REMARKS

The Office Action mailed July 25, 2005 has been carefully reviewed and the foregoing amendments and the following remarks are made in response thereto.

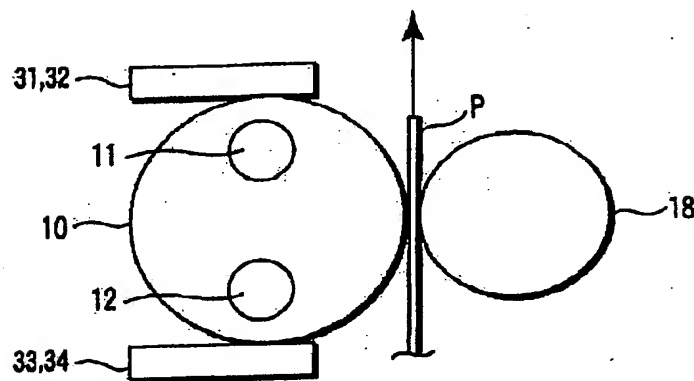
Figure 8 has been amended to label the horizontal axis with the time dimension "minutes" and the vertical axis with the temperature dimension "°C." No new matter has been added. Withdrawal of the objection to the drawings is respectfully requested.

The replacement drawing sheet attached in connection with the above-identified application containing Figures 8 and 9 is being presented as a new formal drawing sheet to be substituted for the previously submitted drawing sheet. Figure 8 has been amended to label the horizontal axis with the time dimension “minutes” and the vertical axis with the temperature dimension “°C.” Appended to this amendment is an annotated drawing sheet of the previously submitted drawing sheet which has been amended to show the changes presented in the replacement drawing sheet.
